**From:** Paul Funk [pfunky@dslextreme.com]  
**Sent:** Friday, September 24, 2010 8:24 PM  
**To:** aram@rpv.com  
**Cc:** avona@pvplc.org  
**Subject:** For Sept. 29th Upper Filiorum Trails Input meeting--Please research and provide info

**From:** SunshineRPV@aol.com  
**Sent:** Sunday, September 26, 2010 9:38 PM  
**To:** aram@rpv.com  
**Subject:** Filiorum Reserve  
**Attachments:** Missing links map -0439.pdf

# Upper Filiorum Reserve Trail Designation Public Meeting

## COMMENTS CONCERNING PROPOSED TRAILS IN THE UPPER FILIORUM- THREE SISTERS AREA

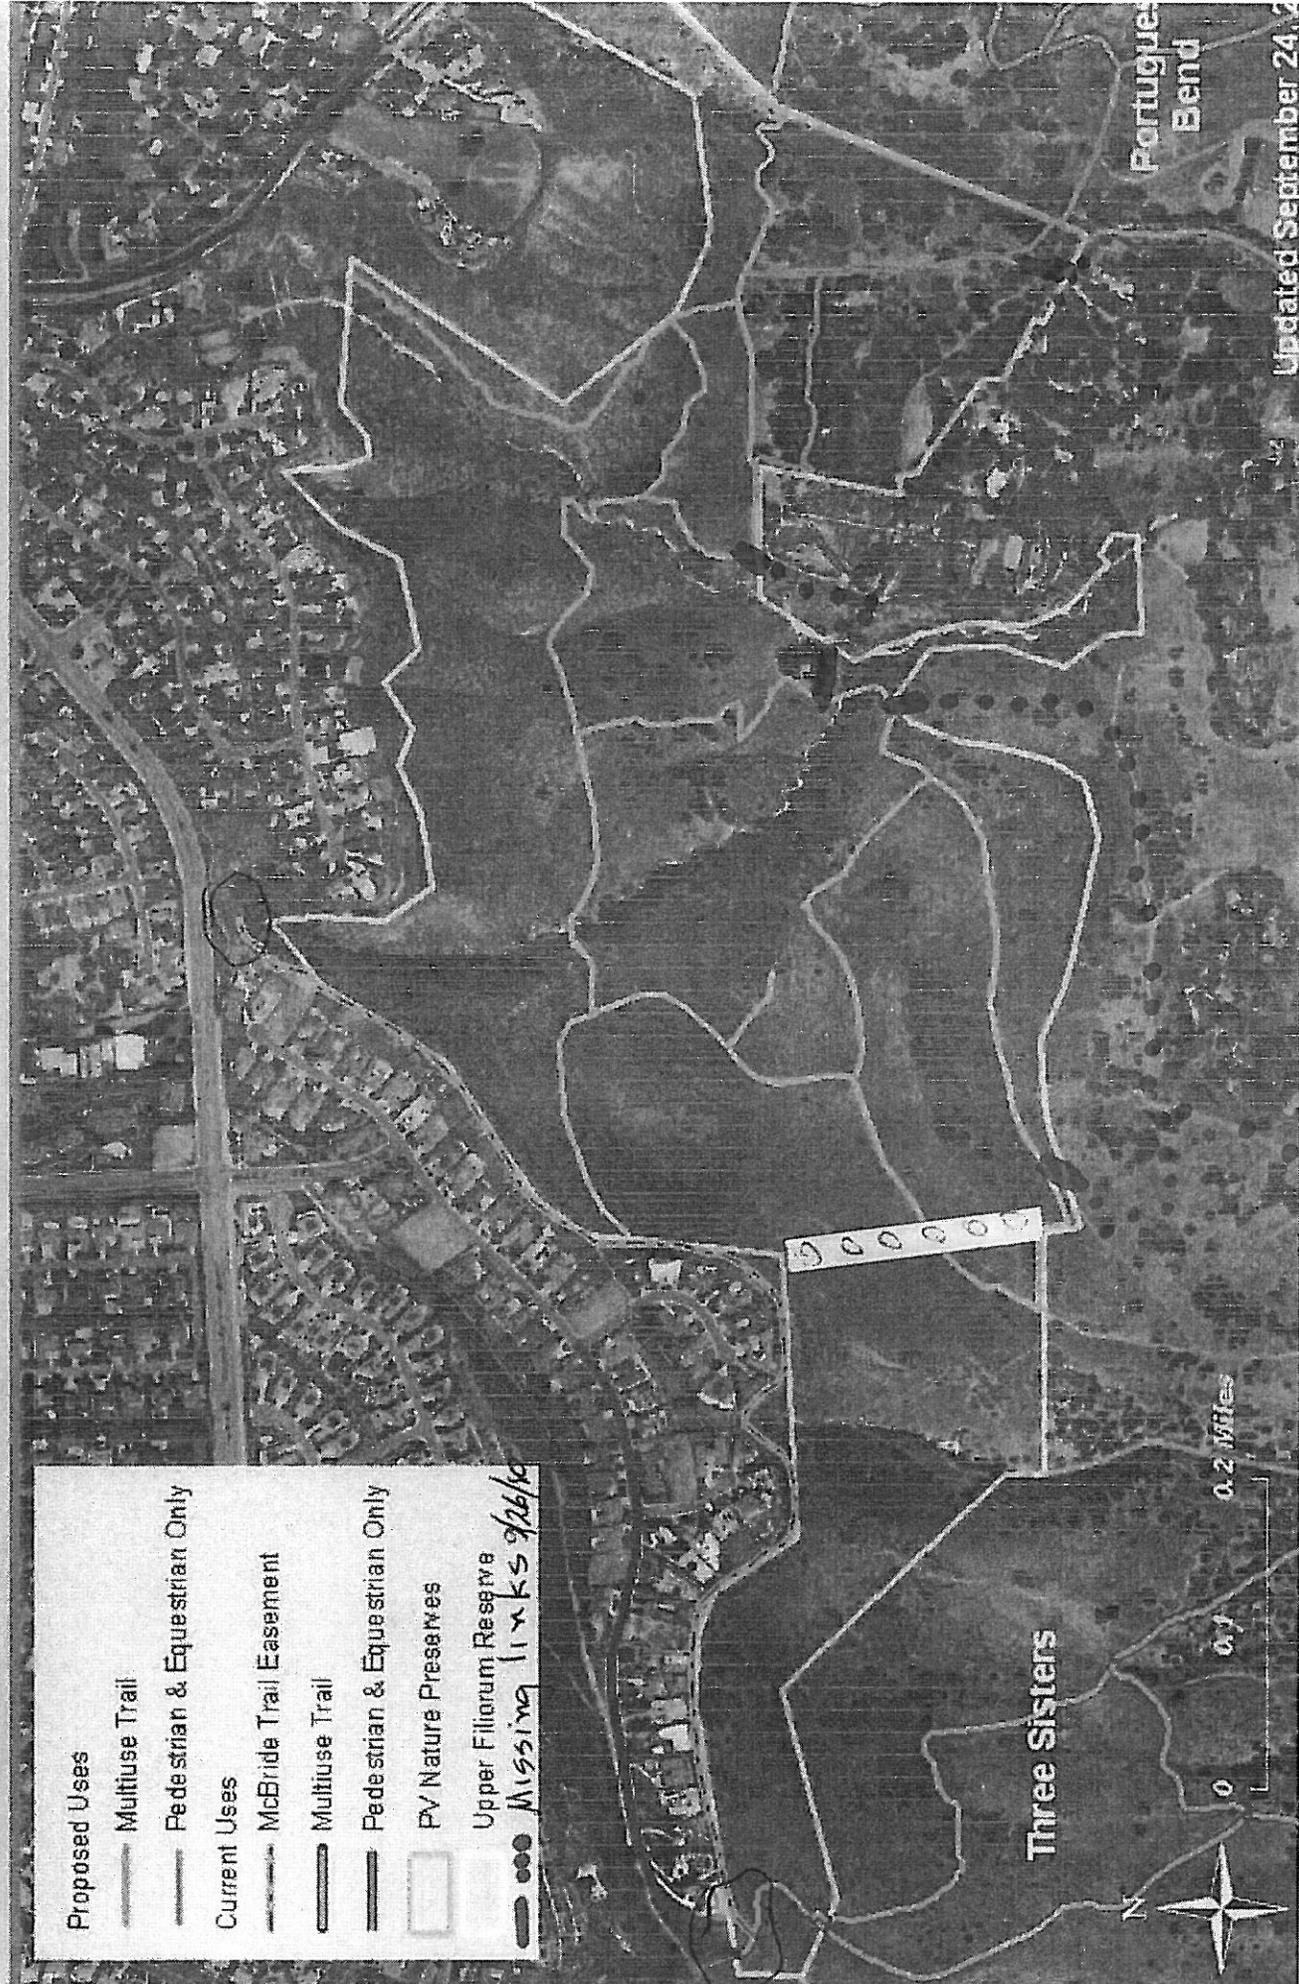
On the attached map, little things first. There is a black circle around each end of the McBride Trail easement where it is shown incorrectly. An easement is a legal access. A trail is a physical access. They are not always at the same place. The City of RPV holds a 30 foot wide trail easement all along the east, south and west (up to Crenshaw) sides of the Island View development. You should show that the public has a legal right to use the top end of the Rattlesnake Trail.

The white stripe with the yellow dots is where I suggest you move the border between the Filiorum Reserve and the Three Sisters Reserve so that all three of the "sisters" are in the Three Sisters Reserve.

My major concern is for the missing links. From a process point of view, how did you decide to show the trail from the Berma Road Trail to the property line in Kelvin Canyon? This trail is not in the Portuguese Bend Reserve Trails Plan.

What I have marked in red are trails which are a similar situation. Trails to the outside world should be on the Reserve maps so that they are maintained on our side no matter what the situation is outside the City's jurisdiction.

Lastly, I object to the use of a trail head symbol to indicate a property line crossing. A trail head is a place where people gather to begin and end a trail use experience. The PUMP Committee never did finish recommending which amenities should be at which entrances to the Reserves. However, crossing an invisible jurisdiction line does not make a trail head. Please, choose some other symbol.

Map 1

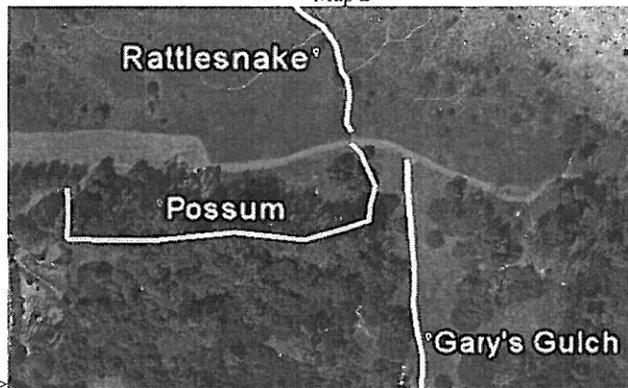
- Designate Gary's Gulch trail as multiuse. Cyclists who ride to the bottom can simply ride back up. I have done this many times. This may allow cyclists who live in Portuguese Bend a legal route into the reserve. Currently, they have none.
- Draw Possum trail route to avoid Gary's Gulch trail. There are several options. Use the current entry from Rattlesnake trail (map 1) or change the start of Gary's Gulch trail (map 2).

Map 3

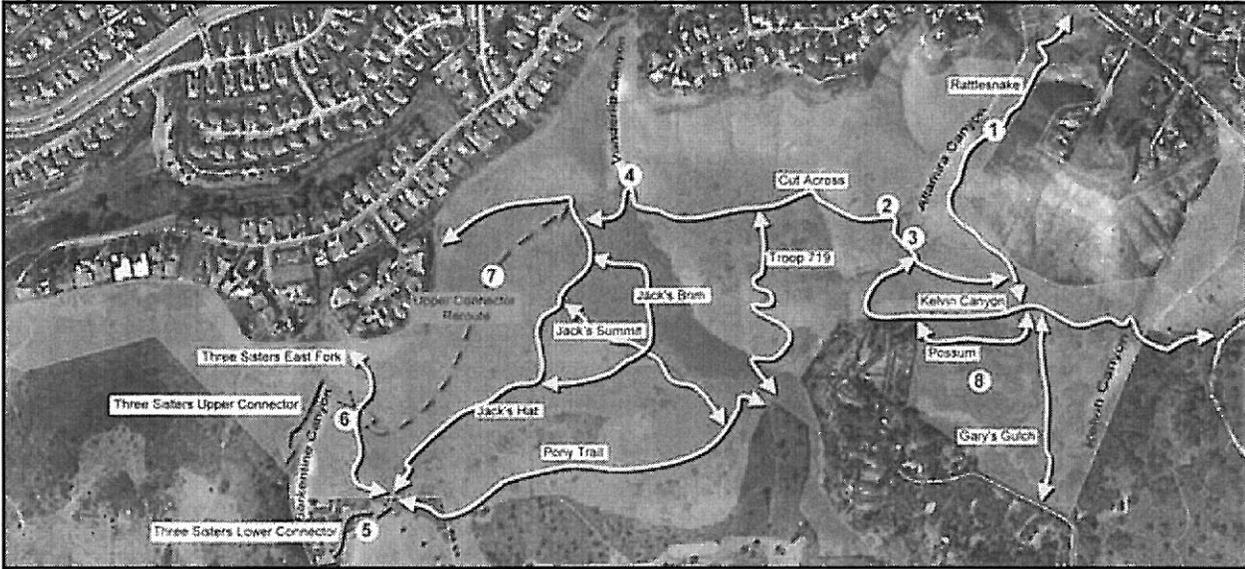
- After being given specific instructions to remove redundant trails, a number of small trails were discarded. However, the public overwhelmingly asked to keep all of the trails on map 3 (below). Even though some trails appear redundant on a two dimensional map they offer significantly different and desirable user experiences. The best example is Jack's Brim trail, which provides an easier route around Jack's Hat and wonderful views of Vanderlip Canyon.
- Trails used for decades by the public are nearly impossible to close or require exceptional effort. The public has already voted for these popular trails with their feet.
- The elimination of unsustainable or difficult to maintain trails usually applies to steep rugged challenging trails. Our trail system needs to provide opportunities for all skill and conditioning levels. Three Sisters East Fork trail provides this kind of experience.

The ideal trails plan would include the trails and designations as show in the map below.

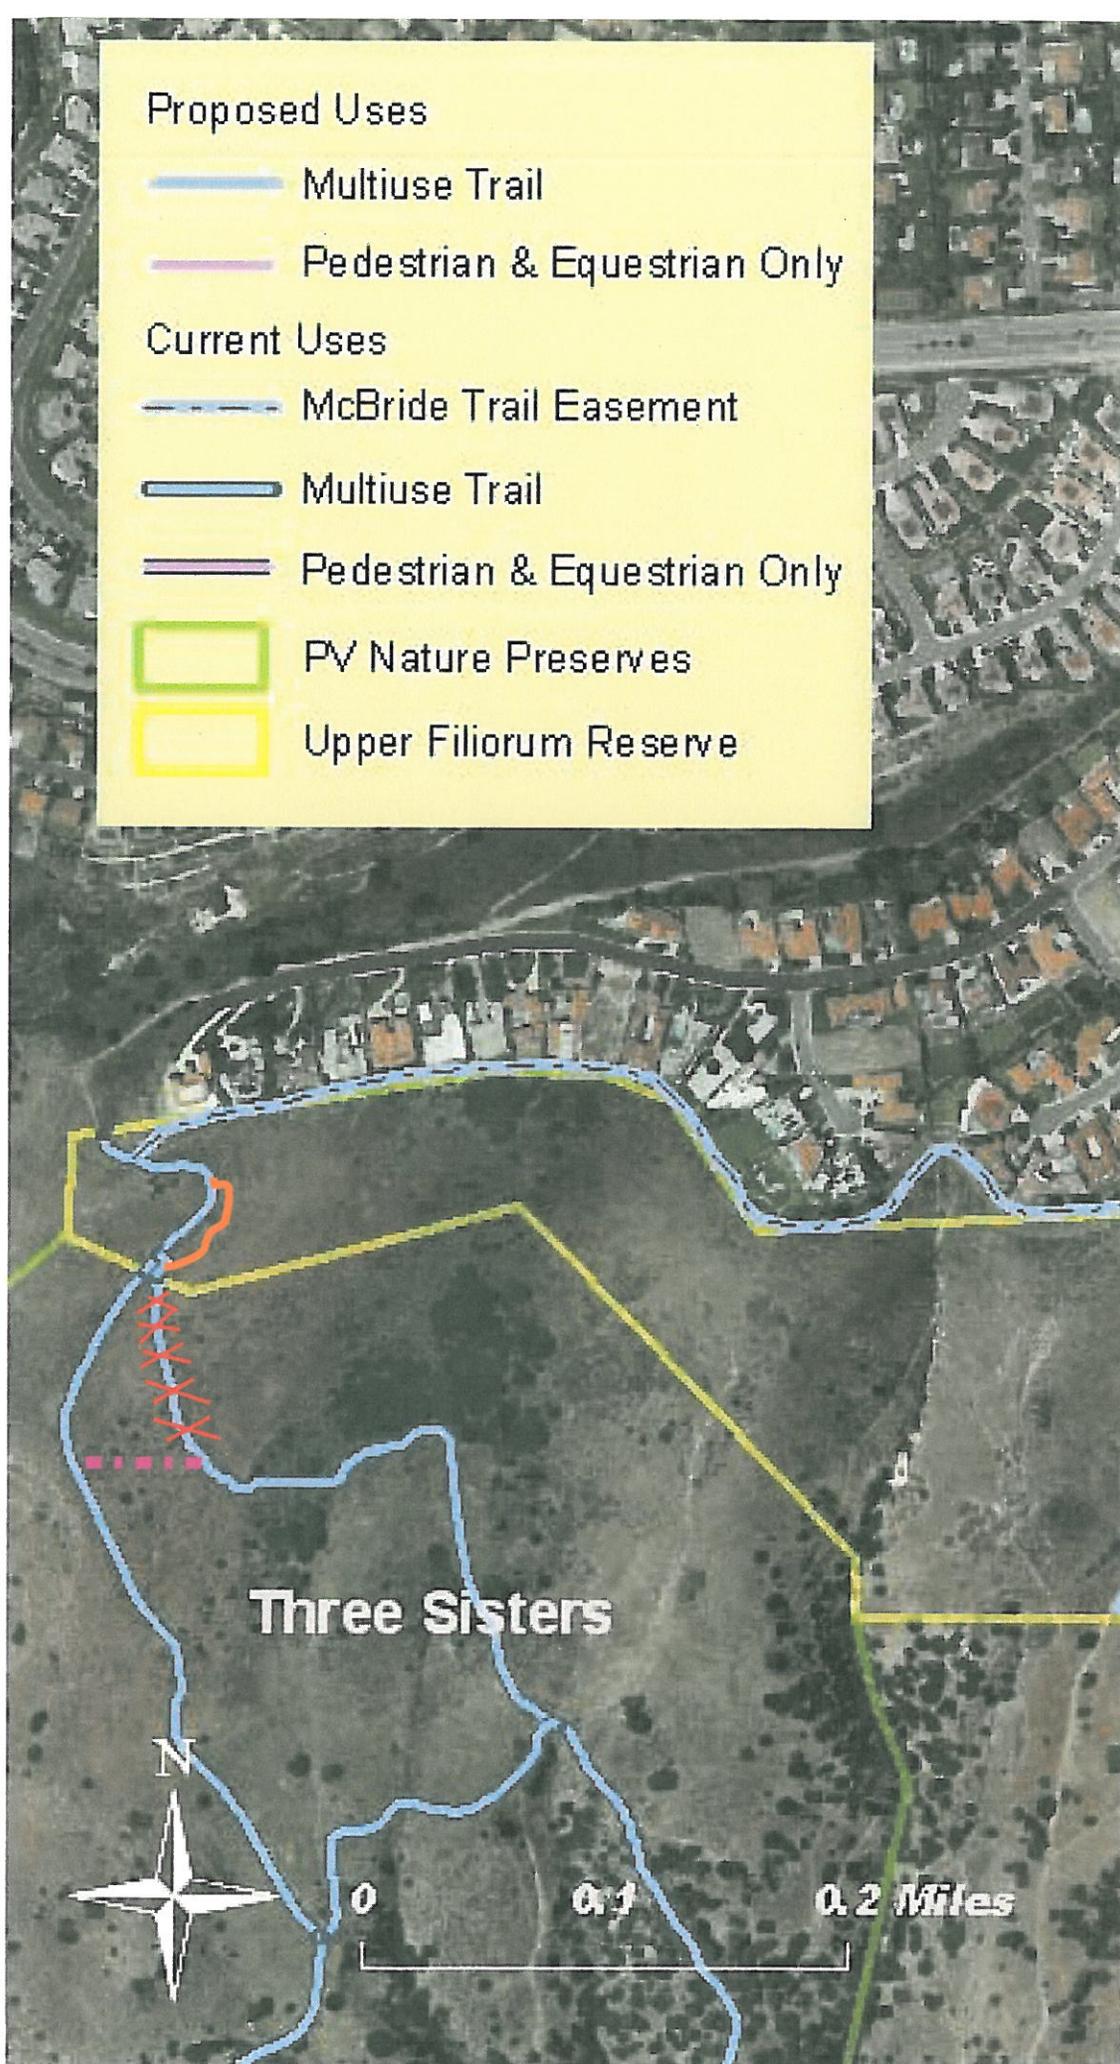
One image is a portion of the City's map of proposed trails with new annotations marking the re-alignment proposed here. The re-alignment is designed to by-pass and eliminate a steep, highly-erodable section of Barkentine trail that nearly parallels the long-standing, nearby McCarroll fire access/vehicle road. The proposed by-pass cross-trail follows an existing trail along a nearly level contour that connects Barkentine Trail to the McCarroll fire access road and avoids the steep face of the natural terrace that suffers from severe erosion.

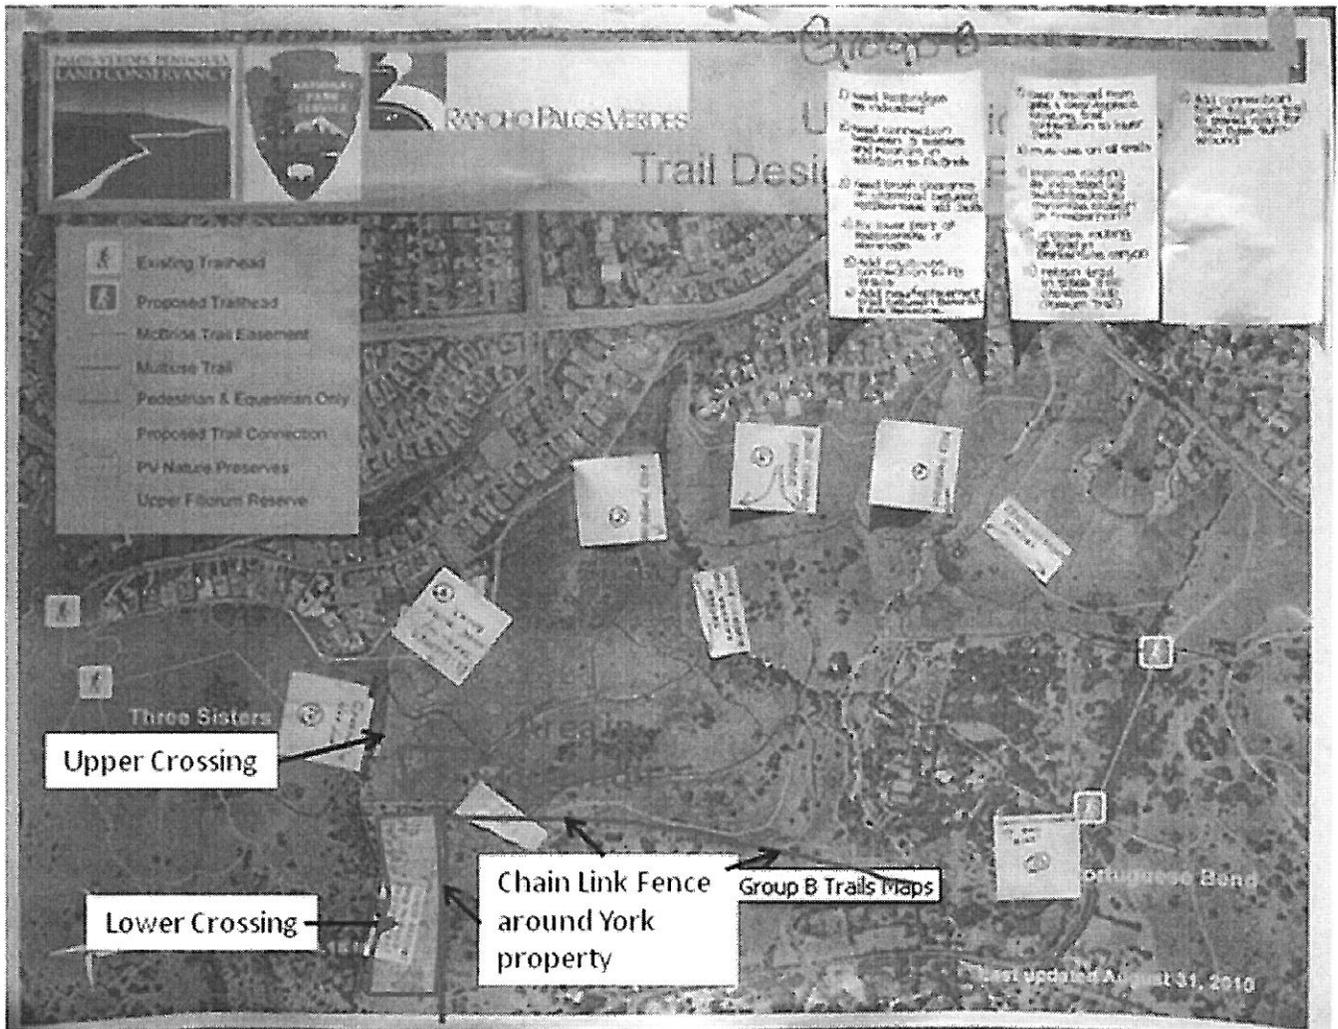
The upper trail is a seldom-used trail which takes off from upper Barkentine Trail and goes down a steep canyon side on the West and up the other (East) side to a point halfway up the ridge to the McBride Trail which most people at the meeting named "The Matterhorn." I have hiked that trail and I believe it is so steep as to not be suitable for a crossing from Three Sisters to Upper Filiorum (of course, that's just my opinion). Here is the map from the meeting to explain what I mean. A picture is certainly worth more than a thousand words.
